# Access Compliance Report

## Public Rights-of-Way

Intersection ID: 52624	Main Street: CORMWELL_LN	Cross Street: CONTEMPORARY_PL	Location: SW
ADA ID: D391BC2BDC35	Ramp Type: Perp	Initial Pass/Fail: Fail	Overall Compliance: No
		Severity Score: 12.5

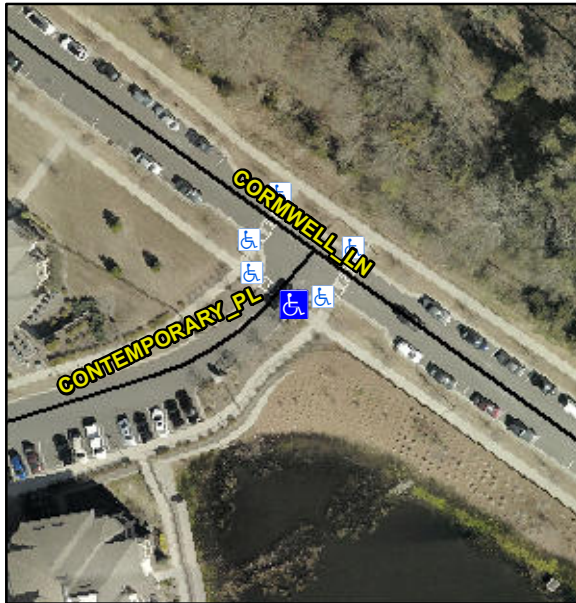
**Not Found, R304.2.2**

Compliance	Description	Data	Compliance	Description	Data
N/A	Ramp Length (in)	99.0	No	Ramp Slope (%)	9.1
Yes	Ramp Width (in)	59.0	Yes	Ramp XSlope (%)	1.6
N/A	Flare Type LT	N/A	N/A	Flare Type RT	N/A
N/A	Flare Slope LT (%)	N/A	N/A	Flare Slope RT (%)	N/A
N/A	Flare Traversable LT?	N/A	N/A	Flare Traversable RT?	N/A
N/A	Landing Length (in)	N/A	N/A	DWS Provided?	N/A
N/A	Landing Width (in)	N/A	N/A	DWS Contrast?	N/A
N/A	Landing Slope (%)	N/A	N/A	DWS Length (in)	N/A
N/A	Landing X Slope (%)	N/A	N/A	DWS Full Width?	N/A
N/A	Landing Curb? (Y/N)	N/A	N/A	DWS Offset (in)	N/A
N/A	Shared Landing?	N/A			
N/A	Gutter Ponding?	N/A	N/A	Gutter Slope (%)	N/A
N/A	Gutter Lip Ht (in)	N/A	N/A	Gutter X Slope (%)	N/A
N/A	Painted X Walk1?	Yes	N/A	Painted X Walk2?	N/A
	X Walk 1 Direction	To NW		X Walk 2 Direction	N/A
N/A	X Walk 1 Width (in)	63.0	N/A	X Walk 2 Width (in)	N/A
	X Walk 1 Slope (%)	2.3		X Walk 2 Slope (%)	N/A
	X Walk 1 X Slope (%)	1.3		X Walk 2 X Slope (%)	N/A

**Remove & Replace Entire Ramp.**
